**LFPCNUSA2023-001**

**Product Change Notification for Littelfuse**

MOSFET DISCRETE, IGBT DISCRETE over 650V in TO-247 package adding new manufacturing location

## 1. POD – Package Outline Dimension

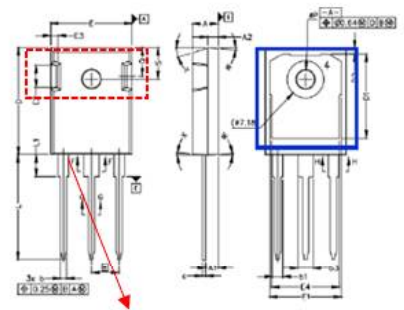
ATX POD has different dimension and shape on body notch area compared to Littelfuse Original POD

**Conclusion:** There is variance between the POD of Littelfuse and ATXWH on outline E2 and L. The variance is not critical which has no significant impact on the application in customer side.

Datasheets will be updated.

#### 4. Label

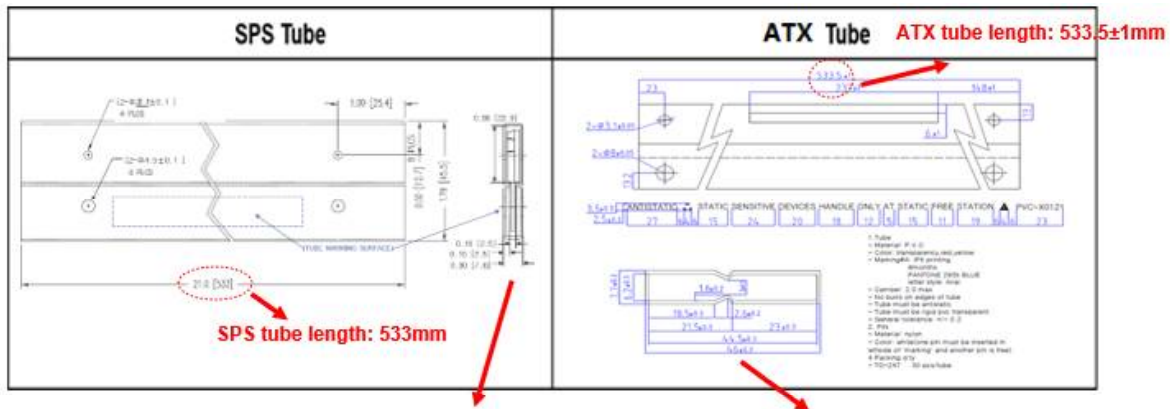
**Note:** (1). No additional change in Label layout for Logo/Part No/Lot No/Qty/Date Code between SPS and ATX. The only change is for assembly location from Korea to China.

**Note:** (2). No additional change in Label layout for Logo/Part No/Lot No/Qty/Date Code between TPC and ATX. However, there is a change on the logo location (TPC: Right-up corner VS ATX: Left-up corner) and assembly location from Philippines to China.

5. Tube Comparison:

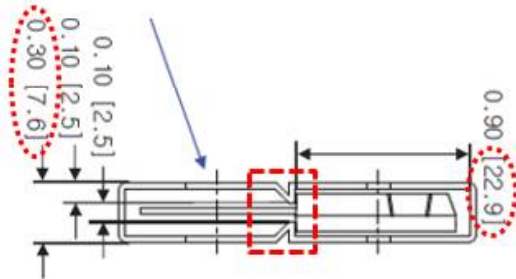
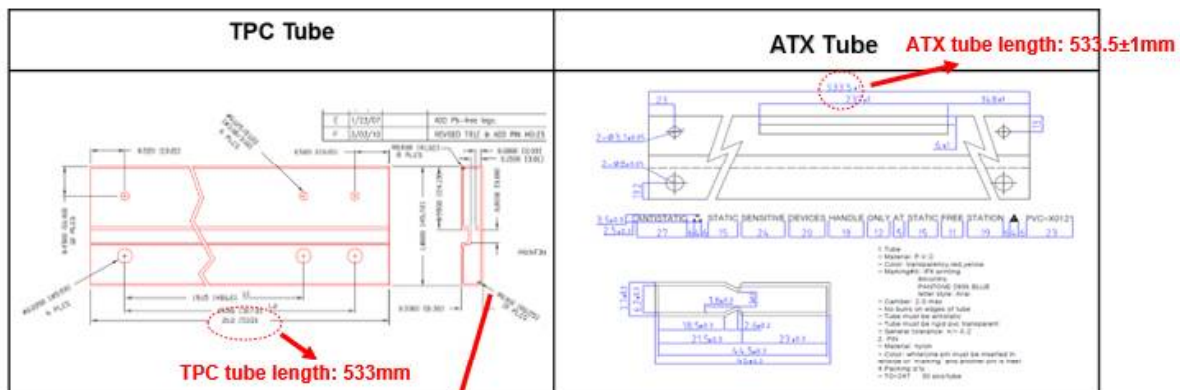
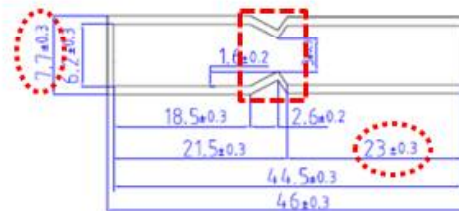
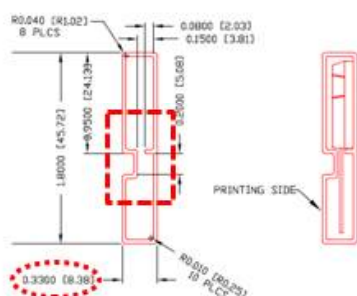
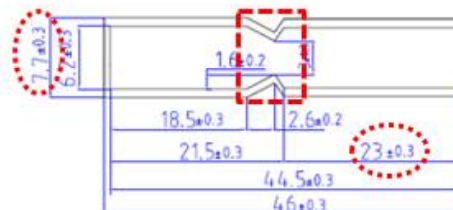
**Conclusion:** There is variance on the packing materials between SPS/TPC and ATXWH, especially on the size and shape of tube cross-section view. The tube variance may affect the units loading/uploading in customer side.
